209-211 Carinish Road, CLAYTON

Planning Permit No. PA240389
Planning Permit Assessment Report
(Clause 52.33)

Officer Assessment Report
Development Approvals & Design

Figure 14: Pedestrian and vehicle movements through the site.

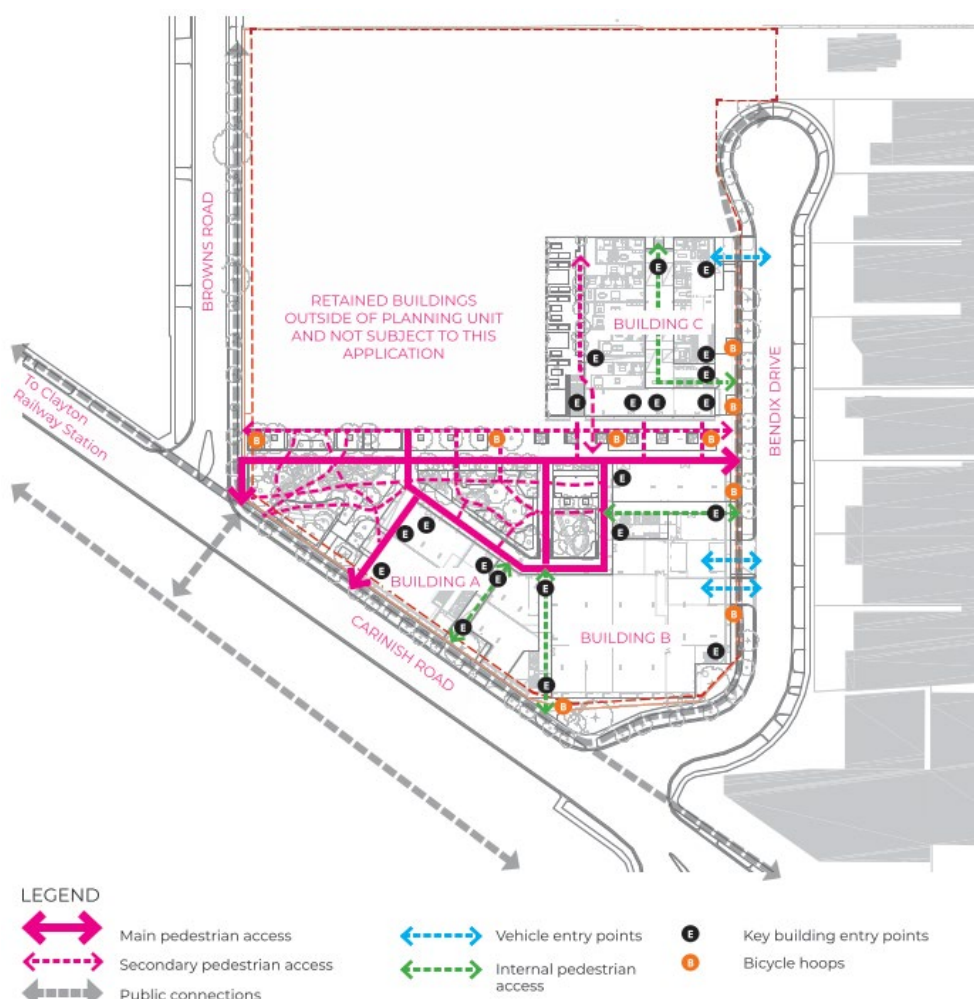
101. Specifically, the proposal would demolish a portion of the existing warehouse building within the southern portion of the subject area and would construct three mixed-use buildings along the southern boundary of the site to Carinish Road and wrapping around to Bendix Drive along the eastern boundary (towards the north). A 1,400 sqm 'Town Square' would be provided within the northwest corner of the subject site, directly abutting the remaining portion of the warehouse building. The Town Square would be vested at a later date to the council. Pedestrian pathways would extend through the subject site extending from the south (Carinish Road) and another pathway extending west to east (Browns Road to Bendix Drive). The pathways would provide access to the Town Square and to an internal landscaped courtyard sandwiched between Buildings A and B to the south and the remaining warehouse building and Building C to the north (see Figure 14).

102. The council has raised a number of issues with the proposed layout on the basis of it being inconsistent with the CDP as it relates to location of proposed buildings, vehicle links, pedestrian links, implications for the broader subject area noting the uncertainty of how the northern portion of the subject area would be developed in the future. The council has raised particular concern with the lack of a shared pedestrian path from the southern boundary of the subject site to the northern boundary of broader subject area as shown in the CDP to remove any ambiguity as to how this would be provided in the future.

Figure 16: Proposed site layout removing angled access street.

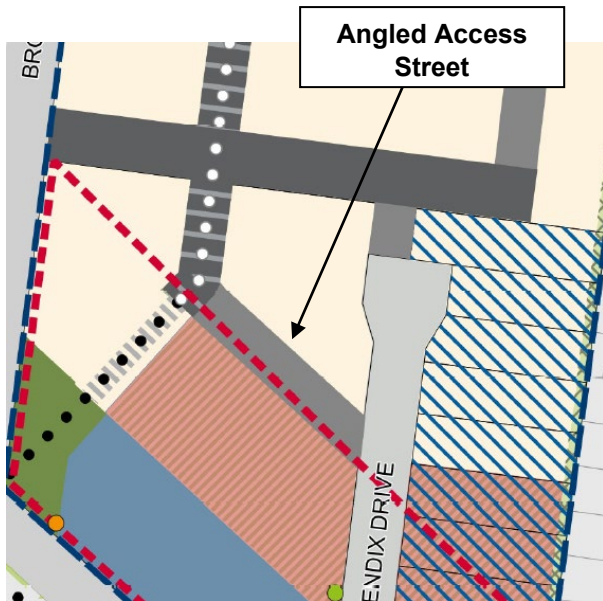
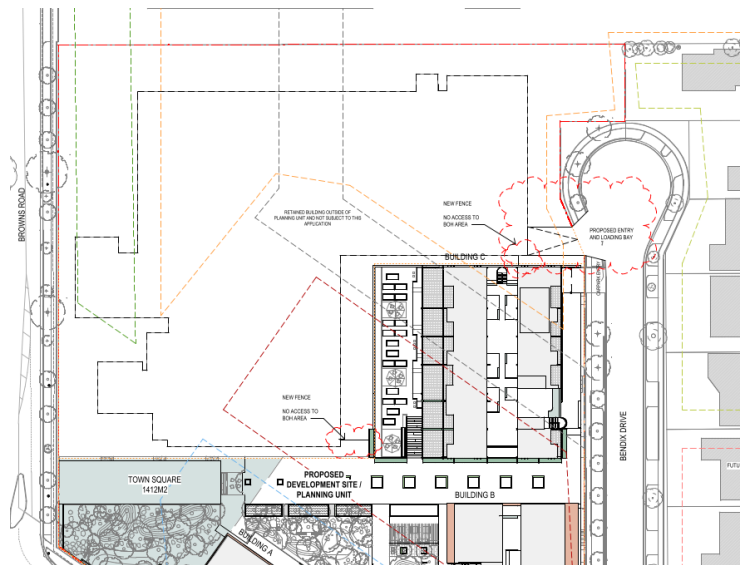
105. The amended layout seeks the removal of the angled local access street from Bendix Drive through the centre of site and the connection to a shared-space access street providing connection to the local access street the north of the site. This change would accommodate the proposed location of Building C (see Figures 15 and 16).

106. The CDP seeks to provide the angled road through the centre of site which would connect to the southern of the north-south shared access street.
107. The applicant has submitted a Memorandum of Advice (memo) prepared by Traffix Group, dated 4 August 2023 in support of the proposed deviation from the CDP. The memo states that instead of providing the north-south shared access street and angled road through the subject area, it would be appropriate to provide a local access street extension to the northern end of Bendix Drive. This outcome would provide a primary movement function for north-south vehicle movements to the northern part of the CDP. The recommendation is based on the assessment of likely primary traffic routes through the site, which would consist of Browns Road (to the west) and Bendix Drive. Further, the angled access street would require a low speed shared zone environment (10 km/h speed limit) while a more direct extension would not require a shared zone low speed environment. The memo also states that the proposal does not prevent a future connection between Bendix Drive and the north-south shared space street directly north of proposed Building C.

Figure 18: Extent of overshadowing at 11am and 2pm on September 22

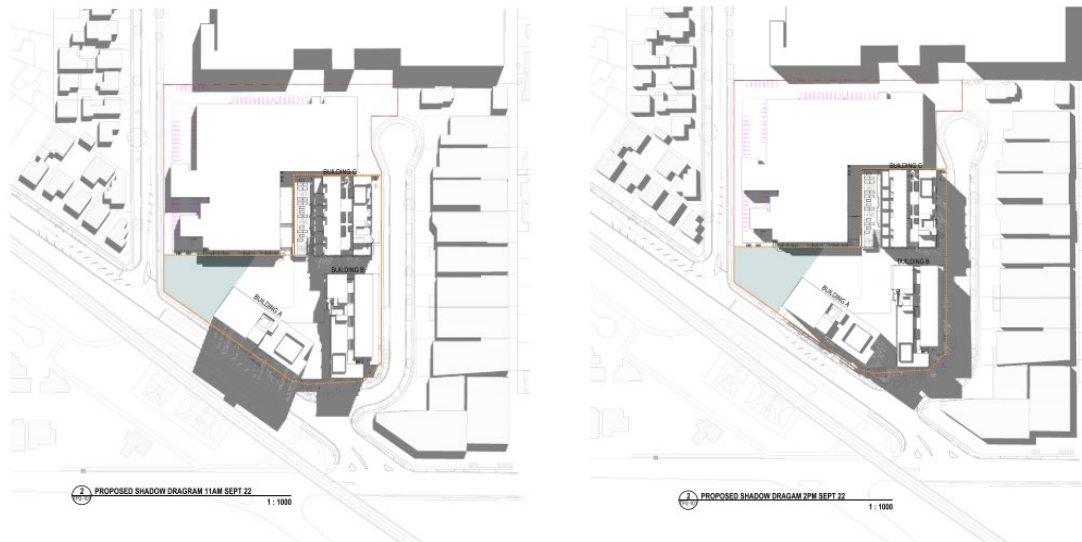
160. While shadows are not provided to show the impacts to the communal open space between 9 am and 10 am, the proposal would still comply with the requirements of Standard D8 at Clause 58 of the Monash Planning Scheme ensuring at least 50% of the open space will receive a minimum of two hours sunlight between 9 am and 3 pm.

161. The extent of overshadowing on public open spaces is reasonably minimised and consistent with the requirements of the Monash Planning Scheme.
